**MAINE TURNPIKE AUTHORITY**

**ADDENDUM NO. 1**

**CONTRACT 2024.08**

**Exit 36 Pavement Repairs**  
**Biddeford/Kennebunk Park and Ride**

The attached Biddeford P&R Curb Plan shall be incorporated into the contract documents.

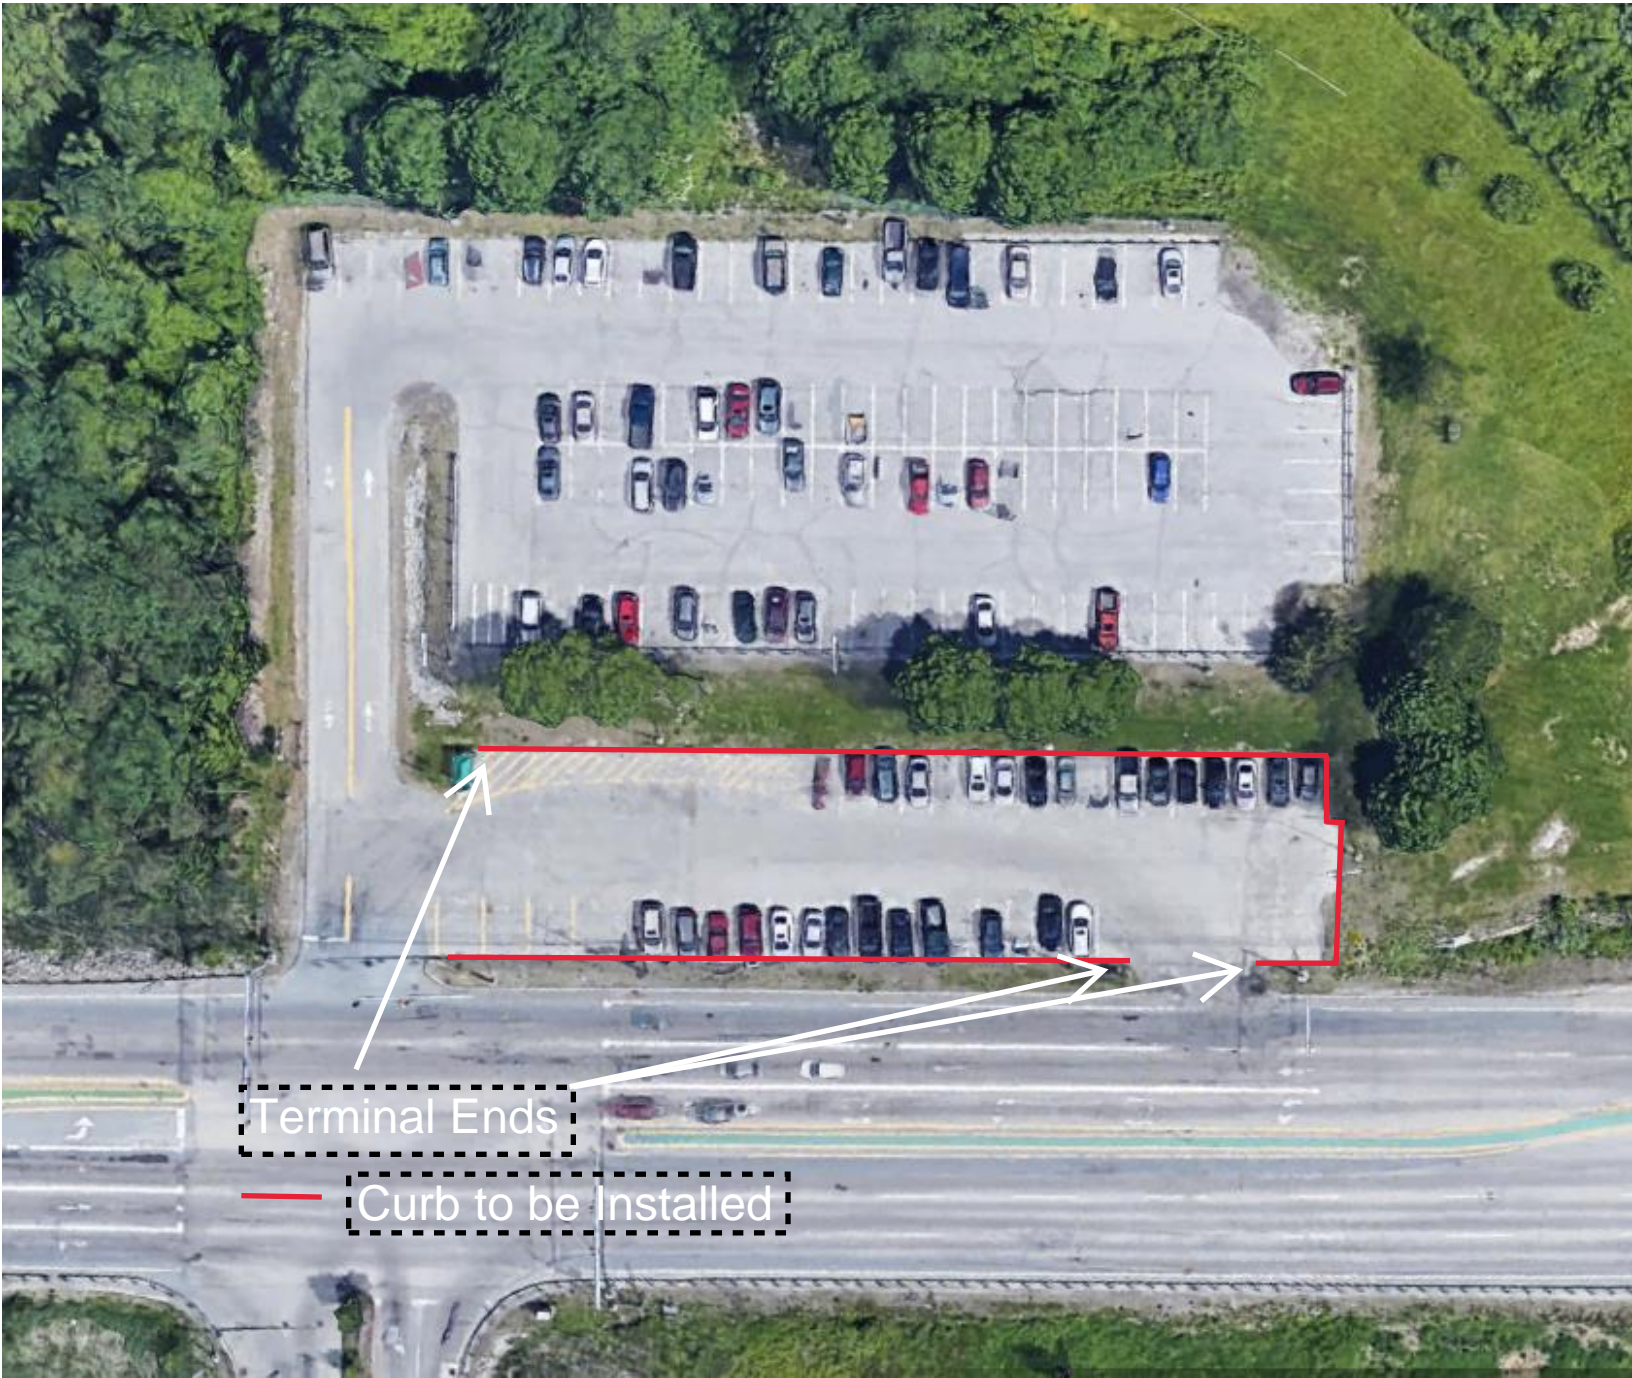
Terminal Ends

Curb to be Installed
